KWM-380 TRANSCEIVER (622-5093-001, -101)
HF-380 TRANSCEIVER (622-3580-001, -101)

SERVICE INFORMATION LETTER 1-88

PRODUCT IMPROVEMENT
RECEIVER-EXCITER CIRCUIT CARD A3 (638-6908-002)

CIRCUIT BOARD BEFORE MODIFICATION

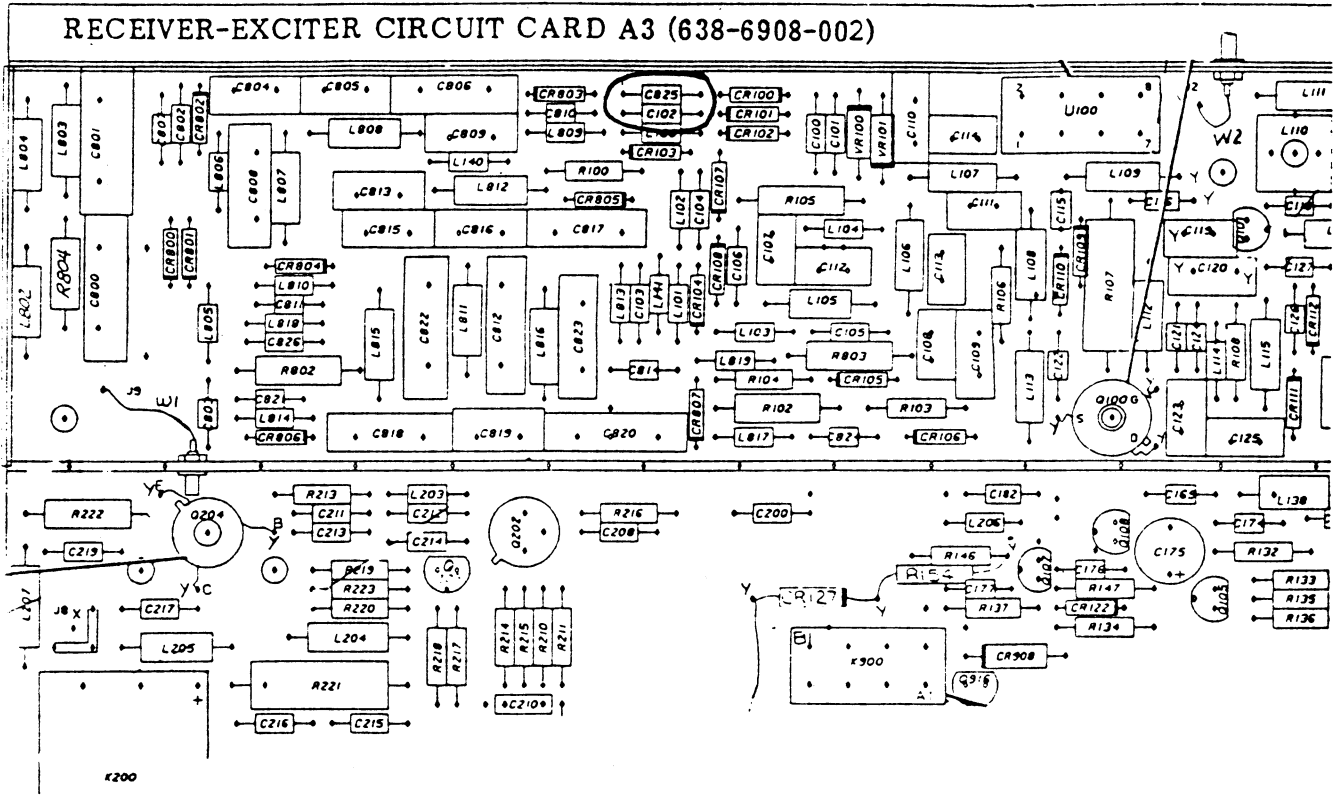
To prevent receiver front end filter select diodes A3CR800 thru CR807 from being damaged or blown by T/R relay A2A2K1 switching transients or large voltage spikes produced at the receive input.

Loss-of or degraded receive signals over that portion of the HF spectrum covered by one or more of the selectable receive front end filters.

Electrically move the receiver front end limiter circuit ahead of the selectable receive high-pass filters and steering diodes.

1. Remove dust cover to gain access to the A3 Receiver/Exciter circuit card on bottom of chassis.
2. Remove shield cover over receiver front-end circuitry.
3. Remove capacitor C102 and discard.
4. Remove right lead of ~~C285~~⁸²⁵ from circuit board and solder into left hole of former C102. Reposition ~~C285~~⁸²⁵ if necessary. Be careful not to push lead or solder through hole too far or a short could occur to the RF shield on the underside of board.
5. Add a piece of #30 insulated bus wire from right hole where ~~C285~~⁸²⁵ was removed to the top of C802. Place bus on circuit board along edge of shield.
6. Replace covers after checking receiver for proper operation.
